Location Address: 2202-2204 Van Buren Street

**SUBJECT:** Preliminary Site Plan review for a 42 Unit residential development.

**APPLICANTS MUST ADDRESS ALL COMMENTS AND FINDINGS AS IDENTIFIED BY MEMBERS OF THE TECHNICAL ADVISORY COMMITTEE BOTH IN WRITING (IDENTIFY PAGE NUMBER OF THE CORRECTION) AND ON THE SITE PLAN (ALL CHANGES MUST BE IDENTIFIED, I.E. BUBBLED).**

**SP-1.1**  
OF SHEETS

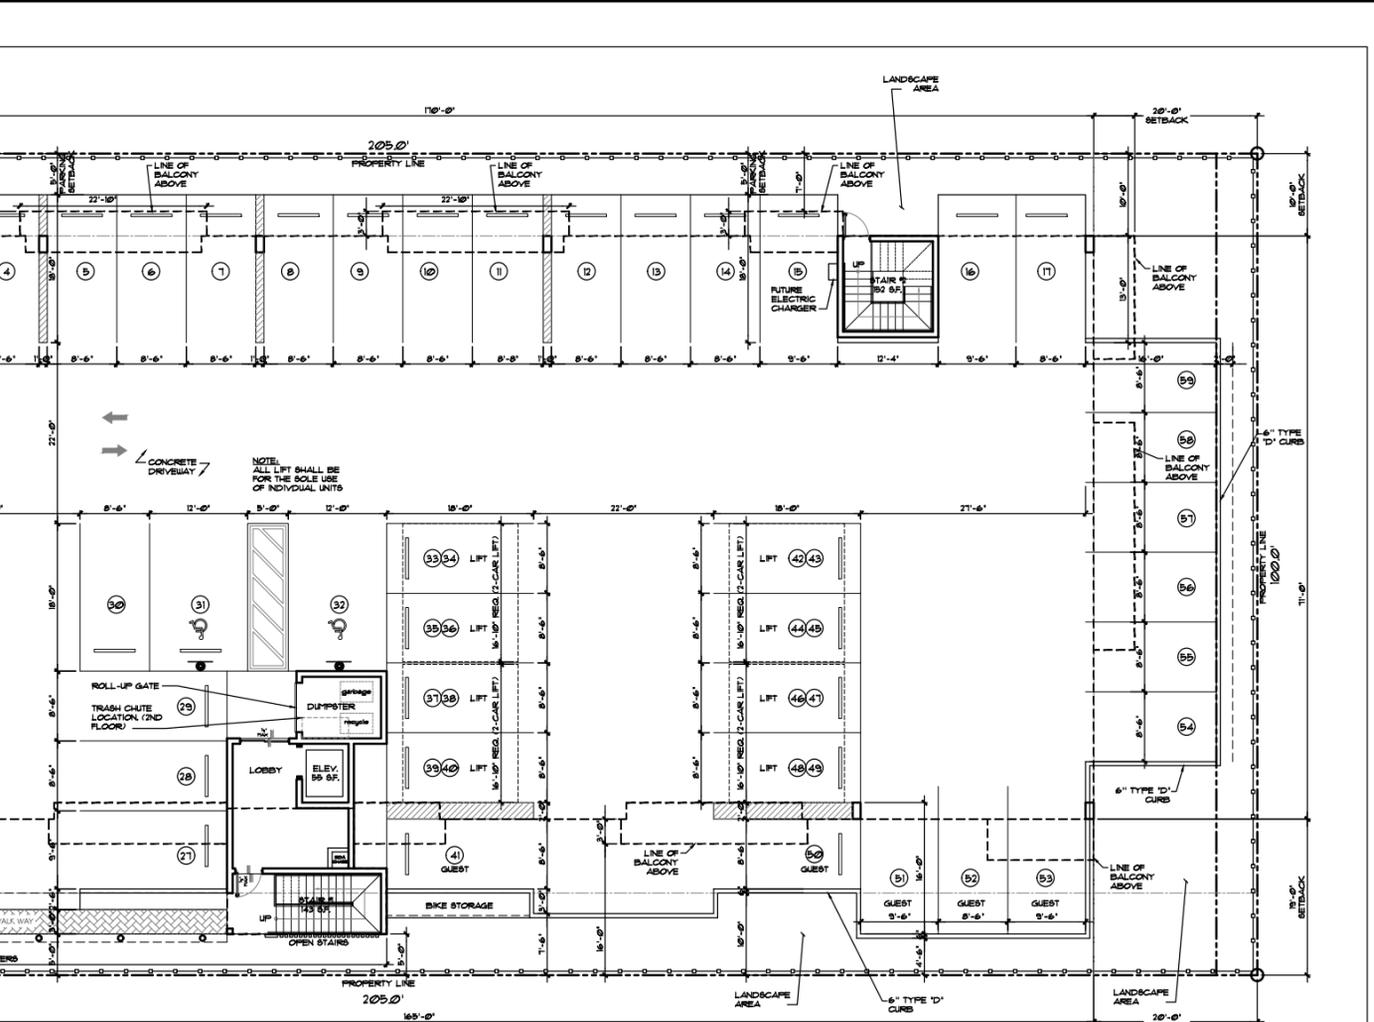
1. As per the City of Hollywood's green building ordinance in Chapter 151, the project will require a third party green building certification since this project has more than 20,000 square feet of total floor area. USGBC's LEED certification or Florida Green Building Coalition certification are the minimum standards. Include which third party certification program this project has chosen in a note on the site plan and provide green registration documentation with next submittal.

2. Indicate on the site plan where the infrastructure necessary for future installation of electric vehicle- charging equipment will be located. (See 151.154, Ordinance O-2016-02) Consider placing it adjacent to a handicapped space so that the future charger will be accessible from both types of spaces.

***Response: Refer to note on SP-1.1***

***Response: Refer to note on SP-1.1***

1 PROPOSED FIRST FLOOR PLAN  
 SCALE: 1/8"=1'-0"

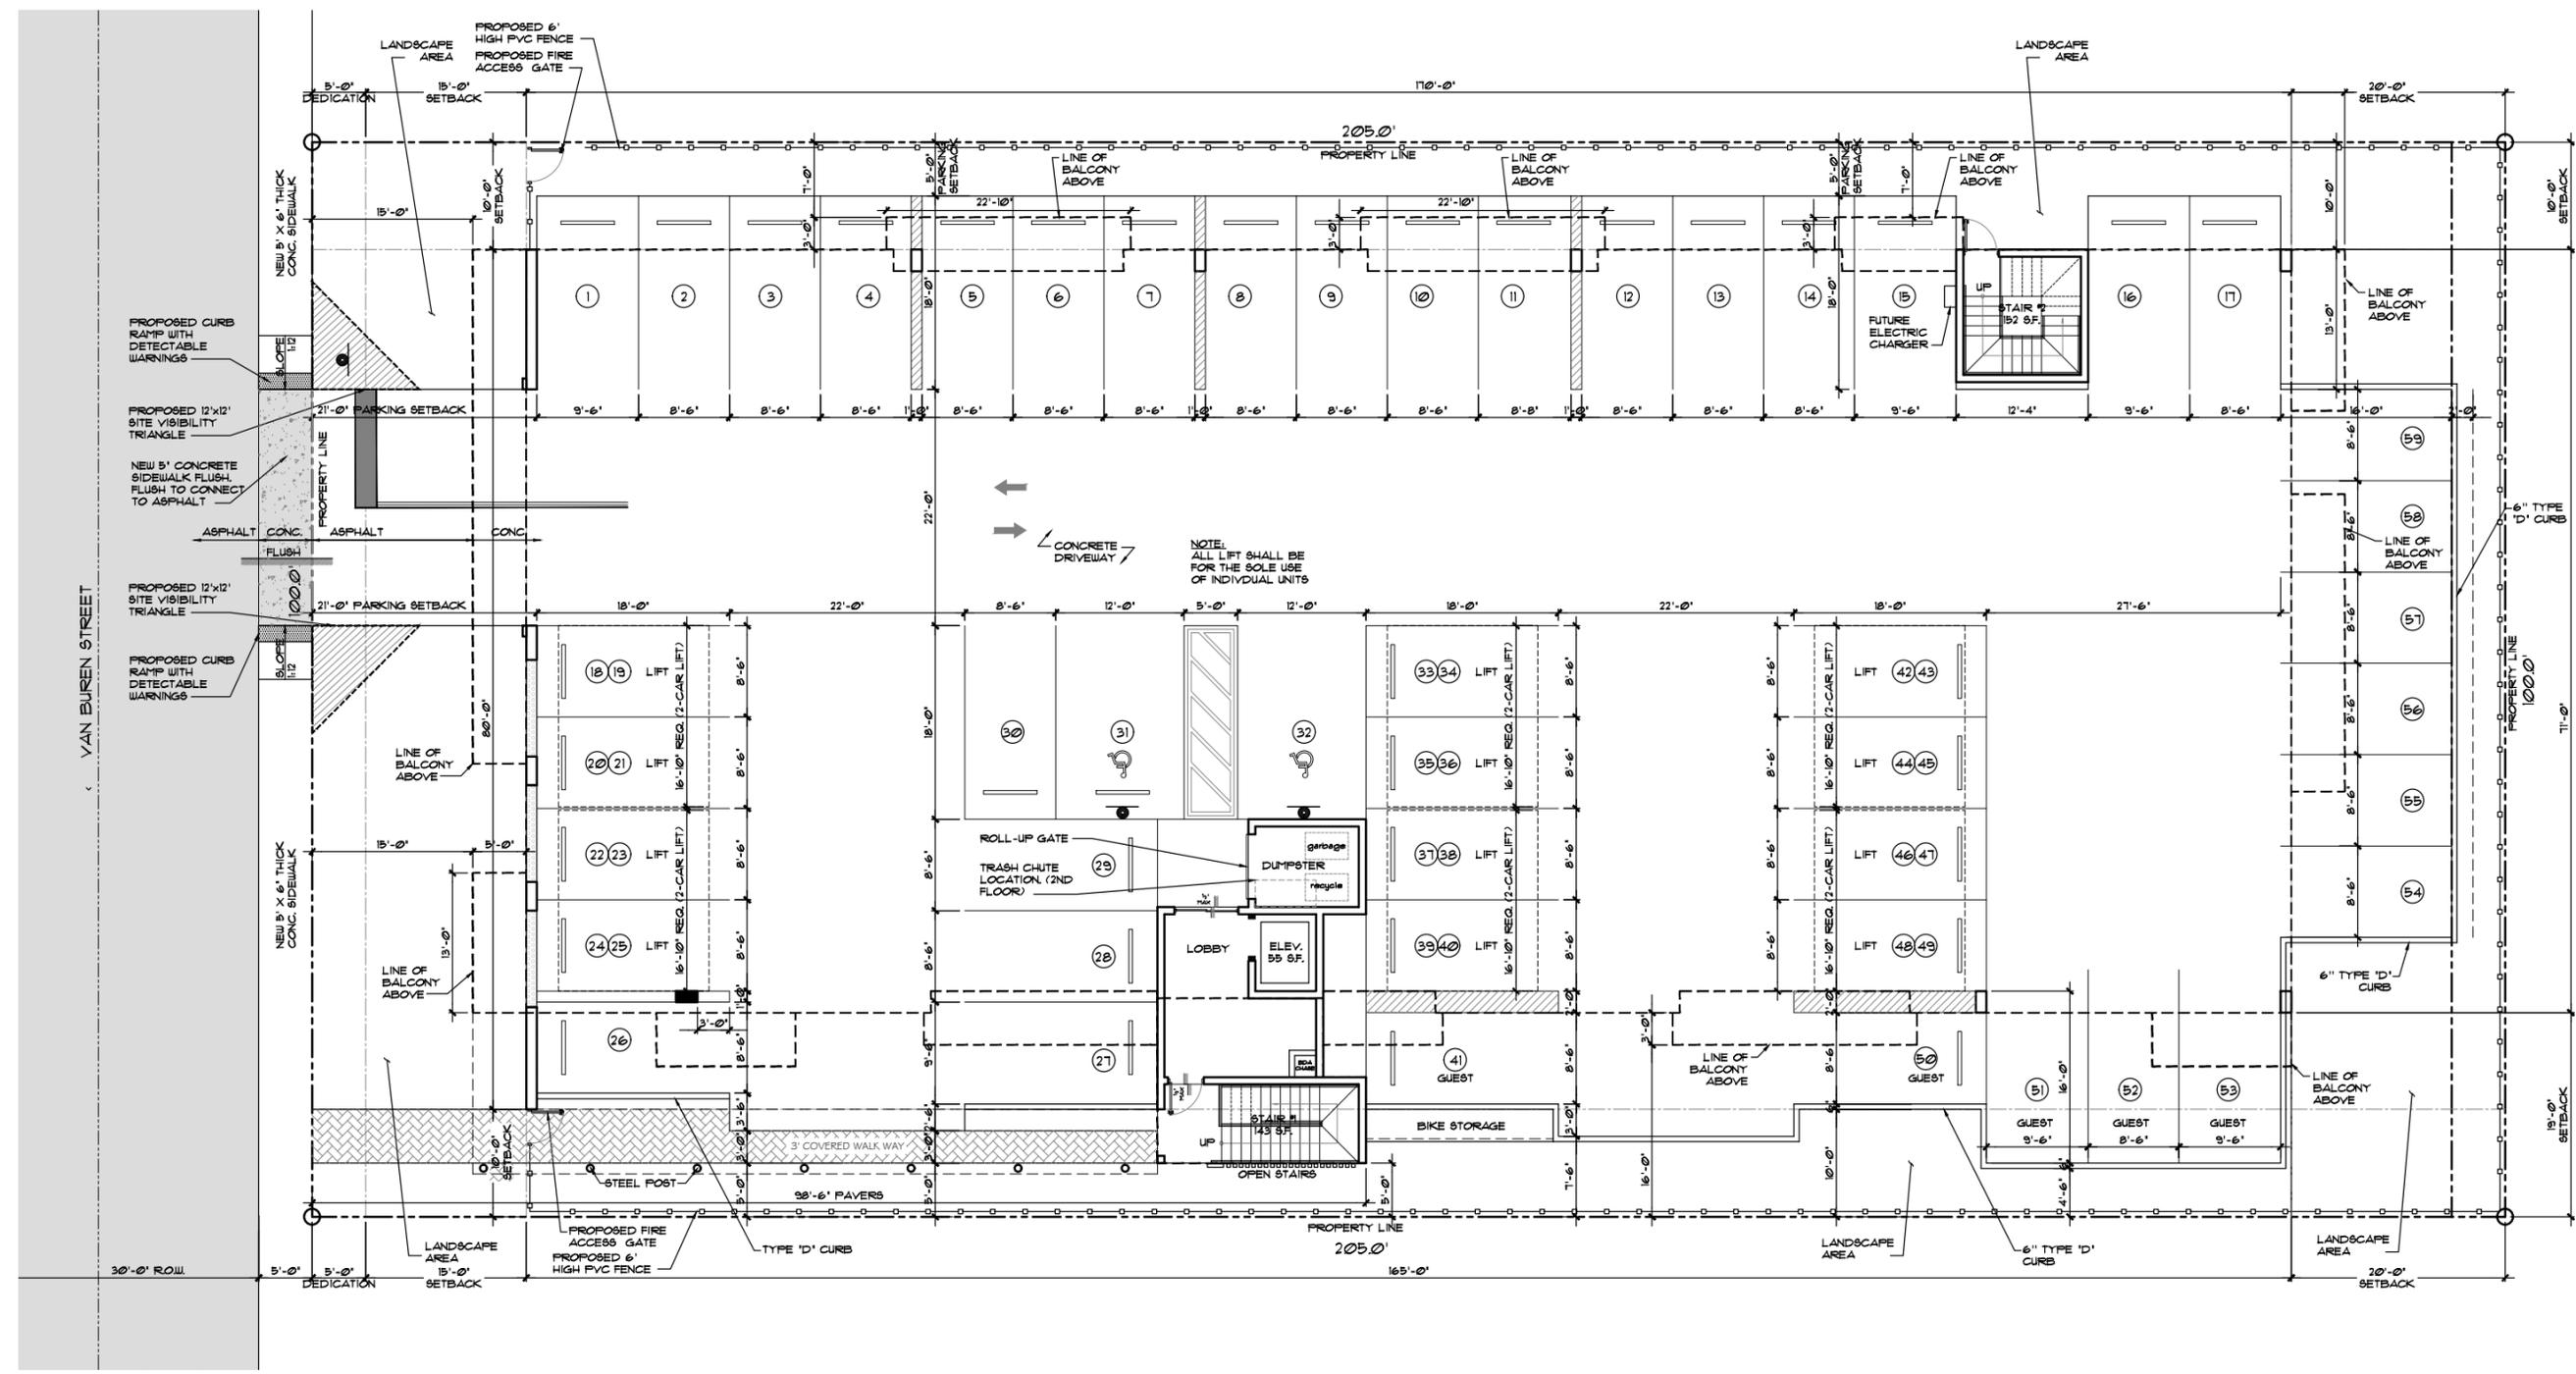
8. Based on the elevations, renderings and site plan, parking space 26 appears to be adjacent to a wall on both sides and is required to be widened to 10'-6".

***Response: Refer to revised Site Plan and Elevation showing column and not a wall***
9. Add a note to the site plan that the parking lift system shall not be for the use of guests.

1 PROPOSED NORTH ELEVATION  
SCALE: 1/8"=1'-0"

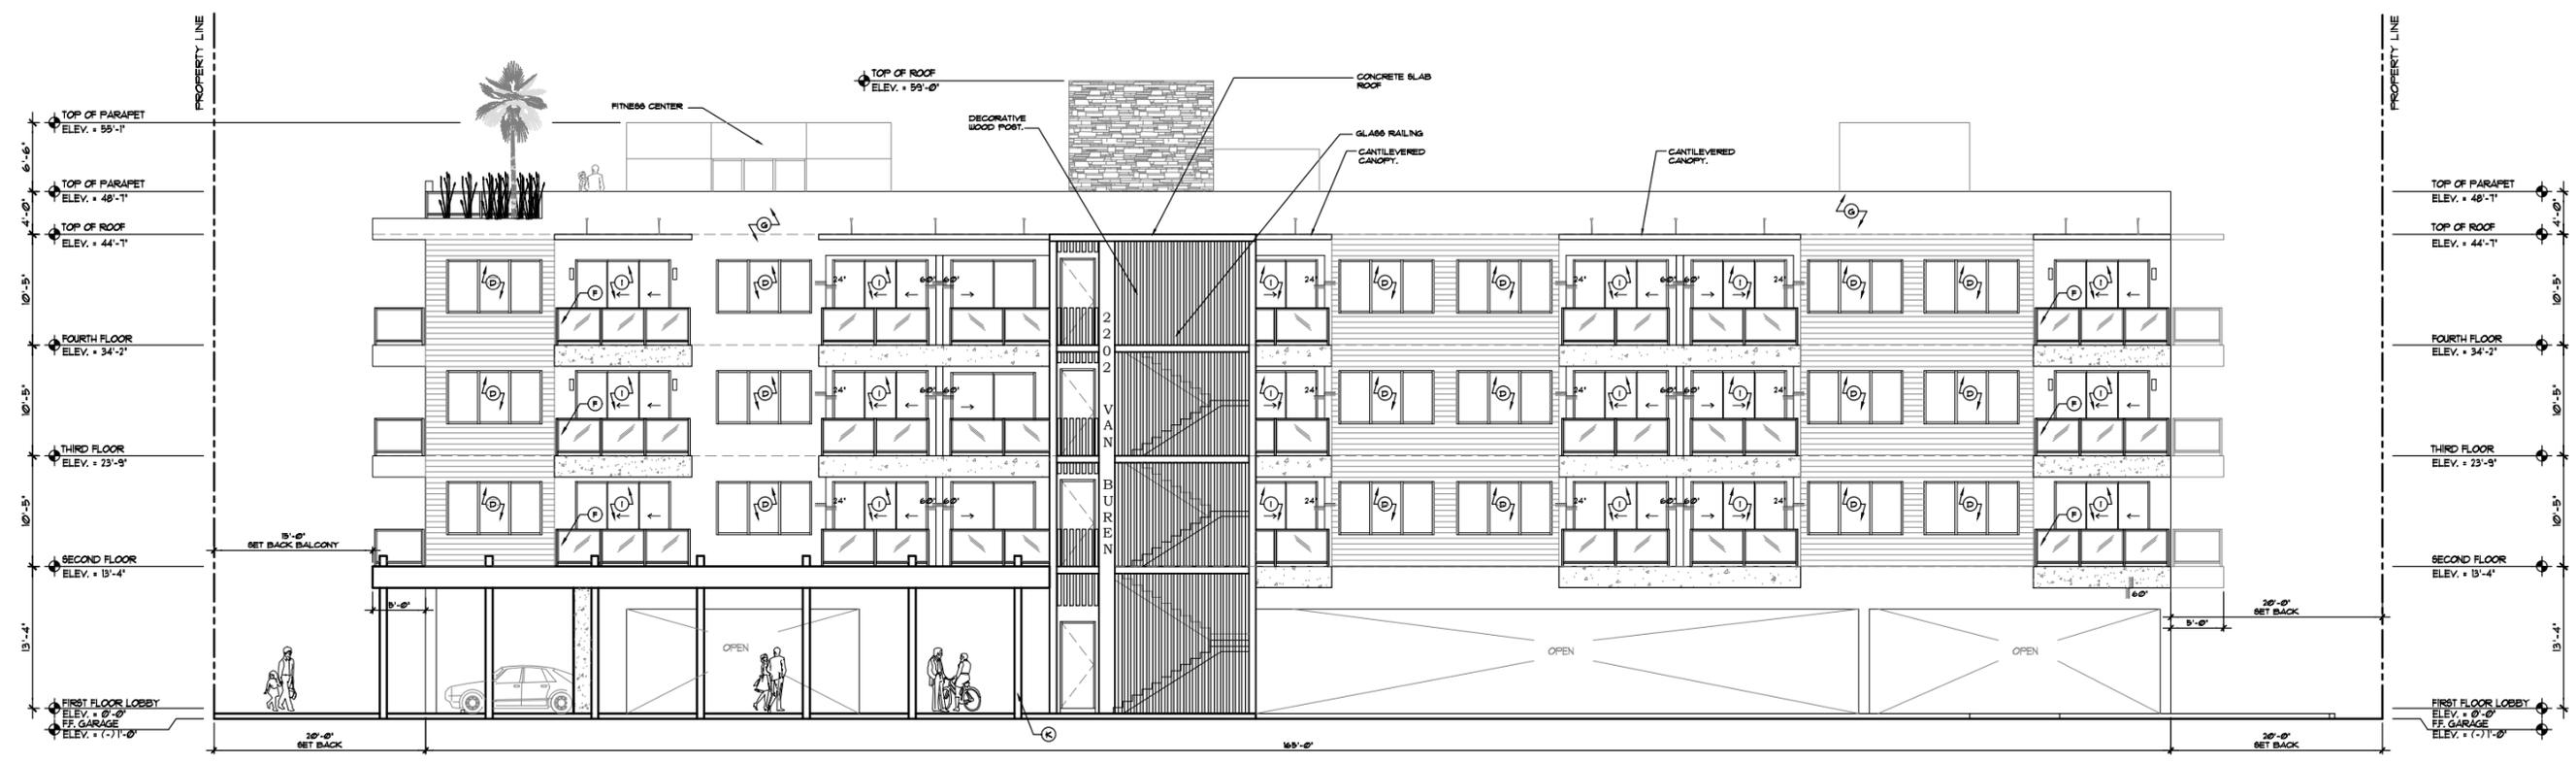
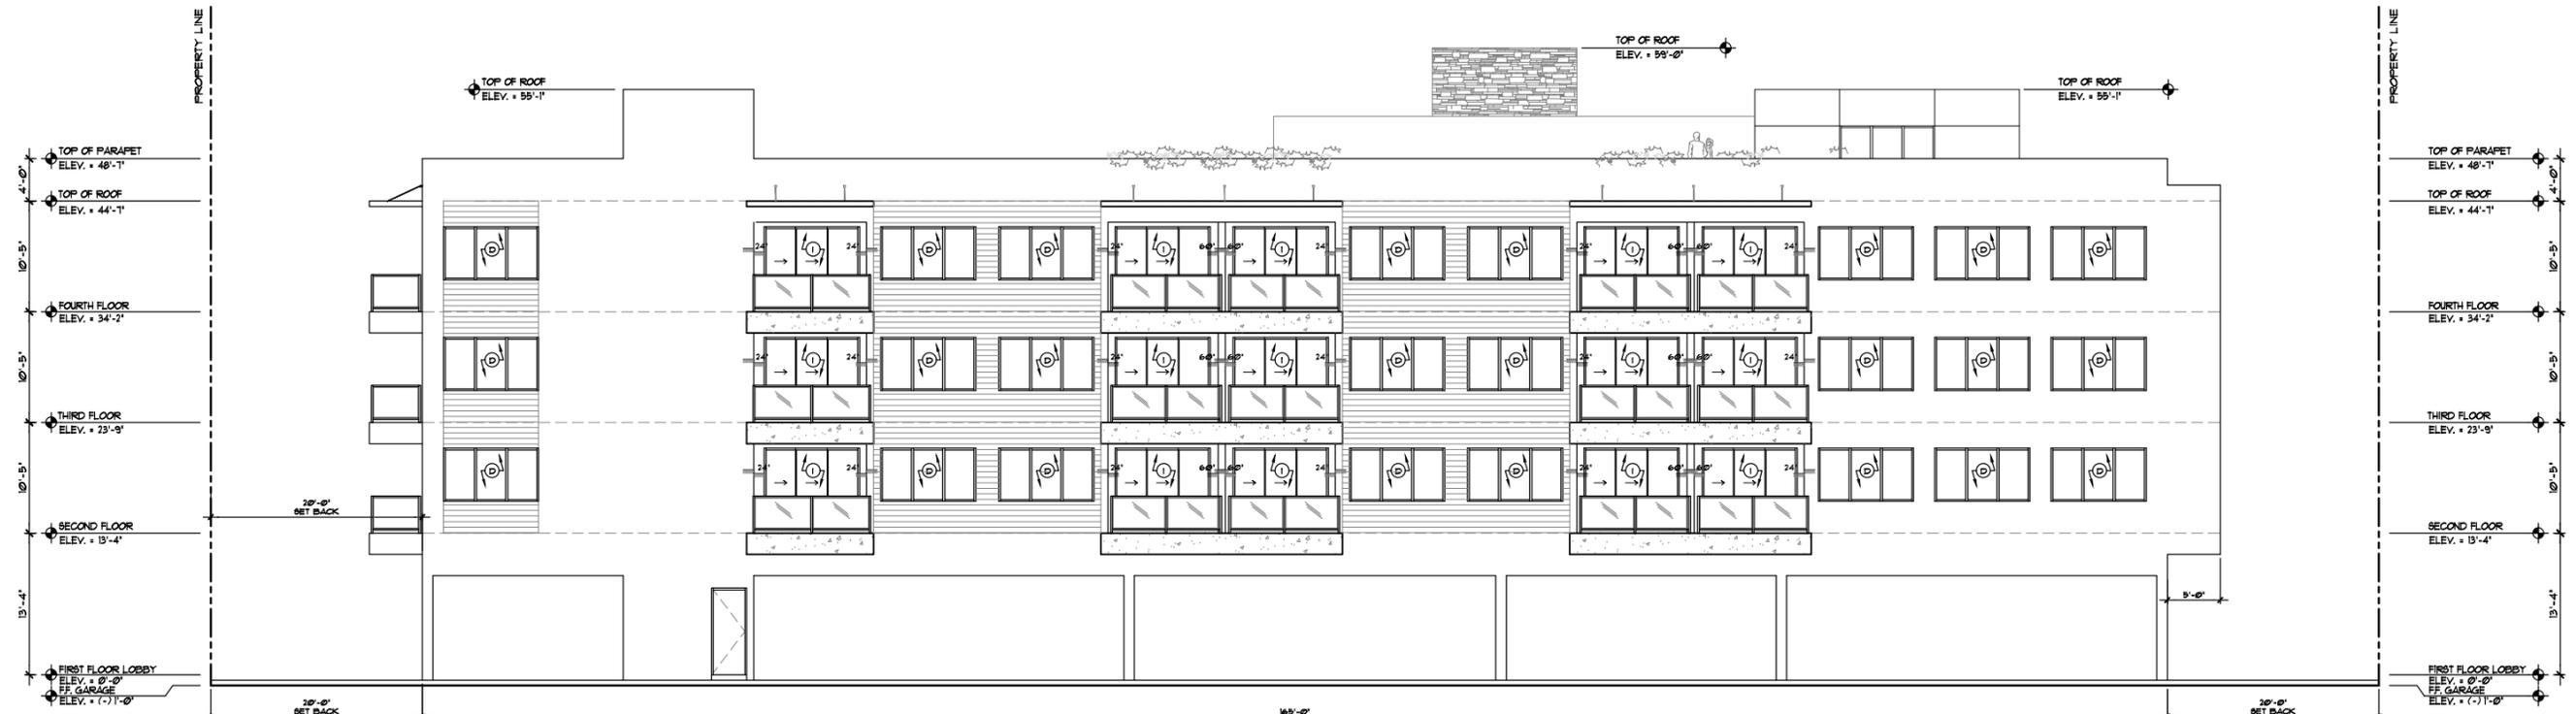
5. The floor plans and roof plan indicate the stairs extend all the way to the roof level, but the elevations do not reflect same. Revise all plans for consistency and ensure design meets setback and height limitation requirements.

7. It is unclear if the east elevation is open on the first floor. The site plans and floor plans suggest it is, however, the elevations are not labelled. ***Response: revised Accordingly***

***Response: revised Accordingly***
